Housing Authority of the City of Pittsburgh

Arch Street Duplex Renovation AMP-39 IFB #600-40-24

ADDENDUM NO. 5

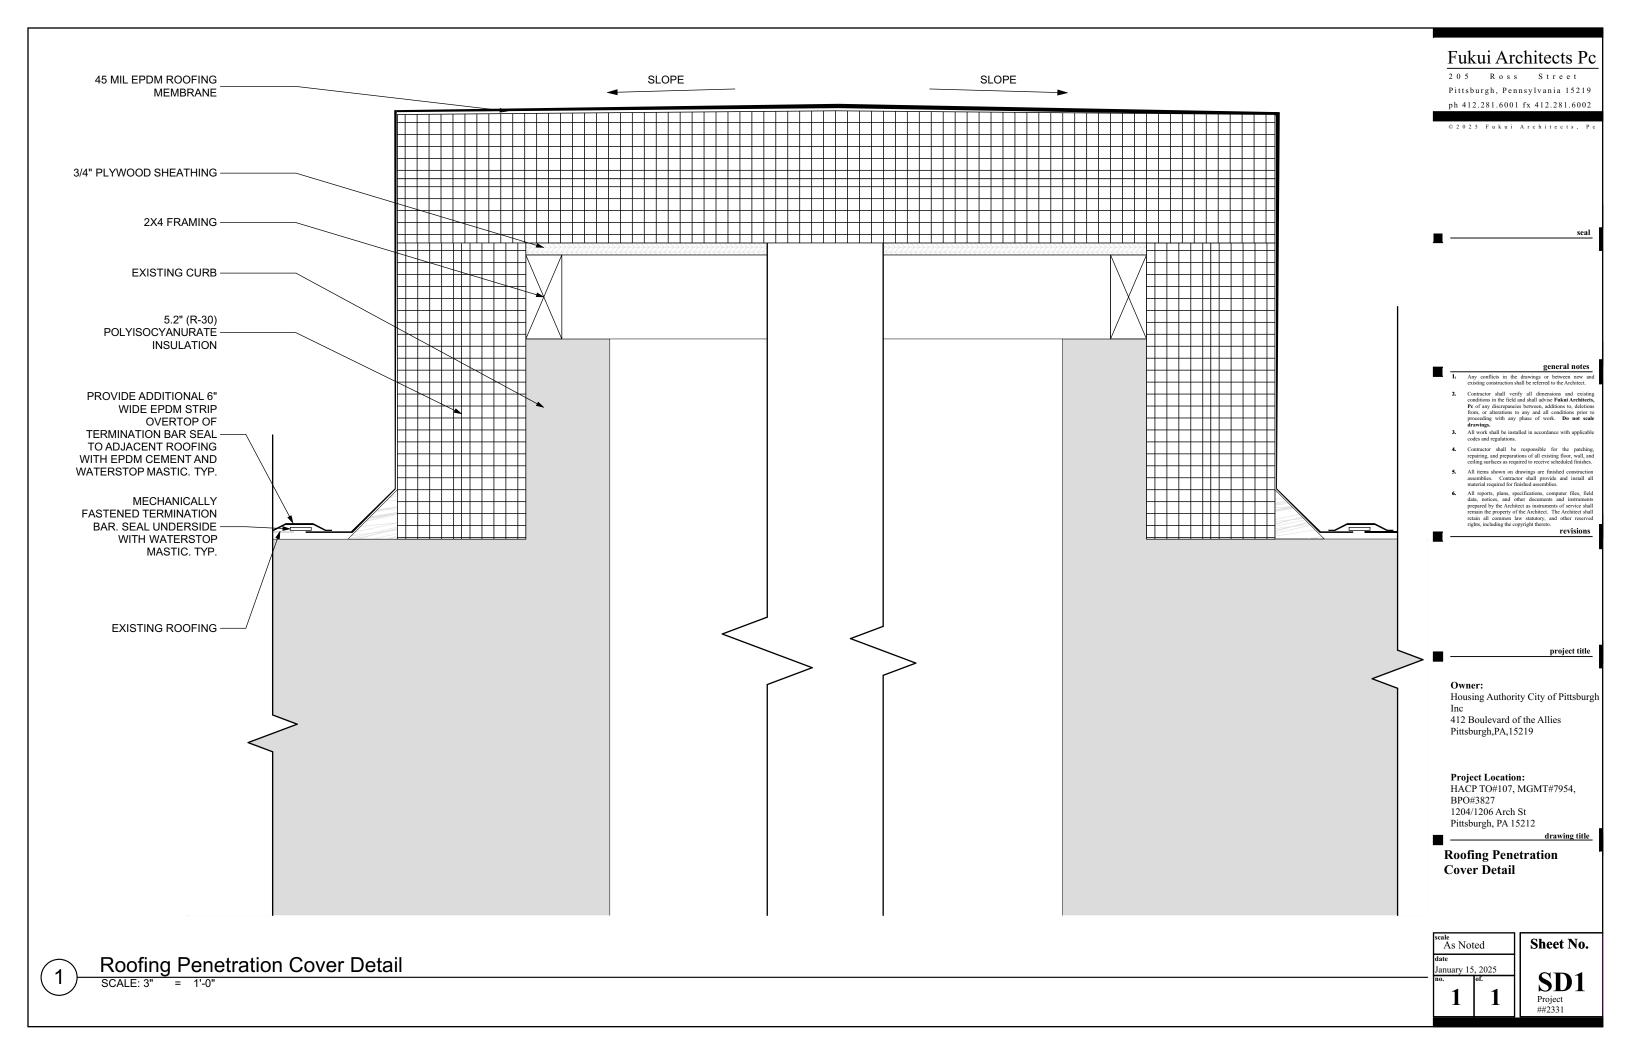
Item 1: Modifications to the Documents- **Specification titled Sheet No. SDI (Roofing Penetration Cover Detail), attached to this Addendum, becomes in its entirety part of the scope of work for the project titled Arch Street Duplex Renovation.**

Sheet A9- the two notes "Roofing penetrations to be repaired with new EPDM." Are revised to now read as the following:

A: The note related to roofing inspections is being removed. See addendum item #1 and #2 above. The scope of new roofing will be limited to covering the existing HVAC penetrations with 2x framing, plywood, 5.2'' (r-30) polyiso insulation, and 45 mil EPDM. See SDI attached and addendum item #3 above.

"Roofing penetrations to be covered. Provide 2x Framing and ³/₄ Plywood over openings. Cover with 5.2" (R-30) Polyiso insulation and 45 Mil EPDM Roofing."
